June 10, 1985

MFN-085-85

SUBJECT: IN THE MATTER OF 238 NUCLEAR ISLAND GENERAL ELECTRIC STANDARD
SAFETY ANALYSIS REPORT (GESSAR), DOCKET NO. STN 50-447; EMERGENCY
RESPONSE INFORMATION SYSTEM (ERIS)

ATTACHMENT 2

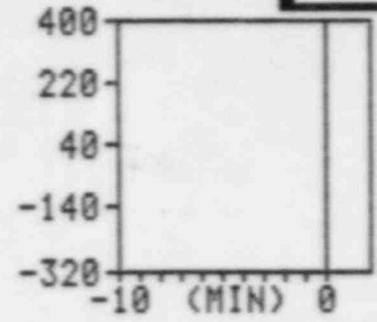
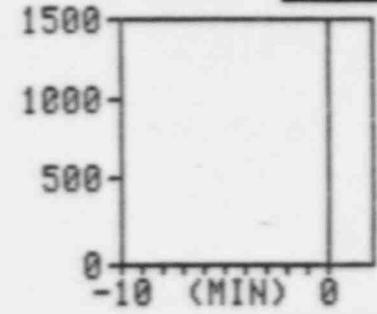
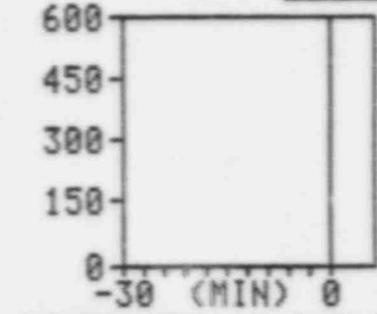
As a result of comments by the NRC Human Factors Specialist (L. Betracchi),
General Electric has reassessed the abbreviations used in the RPV and containment
control system status indicator text. It was found that the total number of
letters could be reduced by about 20 percent without compromising the usefulness
of the displays. The RPV display using the revised abbreviations is shown in
Attachment 2.

Considering both the assessment of our human factors consultant and the input from the NRC, General Electric concludes that modifying displays as shown in Attachment 2 is reasonable. Accordingly, General Electric is prepared to agree to this change for GESSAR if this will resolve the clutter issue.
